Product Change Notification

■Product list PCN2022-12_Report on improvement of the shield board plating in our product DF40GB series

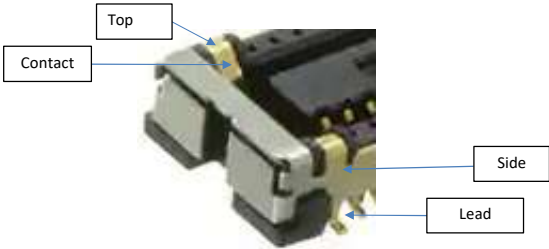
1	Products affected	DF40GB series *Please refer to the attachment for detailed product names.
2	Replacement product	There is no change in product code and product name.
3	Classification of change	Plating Improvement
4	Changes	<p>The gold plating appearance of the shield board will be changed. The current shield board plating technology applies gold plating on the lead, side, top and contact area of the shield in a straight line. As a result, there is a risk that solder will rise to the contact point on the top surface in case of the large amount of solder or the different reflow conditions from our recommendations. This time, we have established a processing technology that applies gold plating only to the lead and contact area, so we will implement this improvement to suppress the spread and reduce the risk of solder rise. Although there is a change in the appearance of the shield board, there is no change in product performance.</p>  <div style="display: flex; justify-content: space-around;"> <div style="text-align: center;">  <p>Side (Before Change)</p> </div> <div style="text-align: center;">  <p>Side (After Change)</p> <p>Lead Area (Gold plating)</p> </div> </div> <div style="display: flex; justify-content: space-around; margin-top: 10px;"> <div style="text-align: center;">  <p>Top (Before Change)</p> </div> <div style="text-align: center;">  <p>Top (After Change)</p> <p>Contact Area (Gold plating)</p> </div> </div> <div style="display: flex; justify-content: space-around; margin-top: 10px;"> <div style="text-align: center;">  <p>Side (Before Change)</p> </div> <div style="text-align: center;">  <p>Side (After Change)</p> </div> </div> <p>From the comparison photos before and after the change, it can be seen that there is gold plating spread on the side and top of the shield board before the change, and thus cause solder rise on the side after mounting. The improved product has suppressed gold plating spread and solder rise after mounting.</p>

5	Reason for change	To reduce the risk of solder rise
6	Schedule of change	We are planning to switch to the improved product from June 2023 onwards.
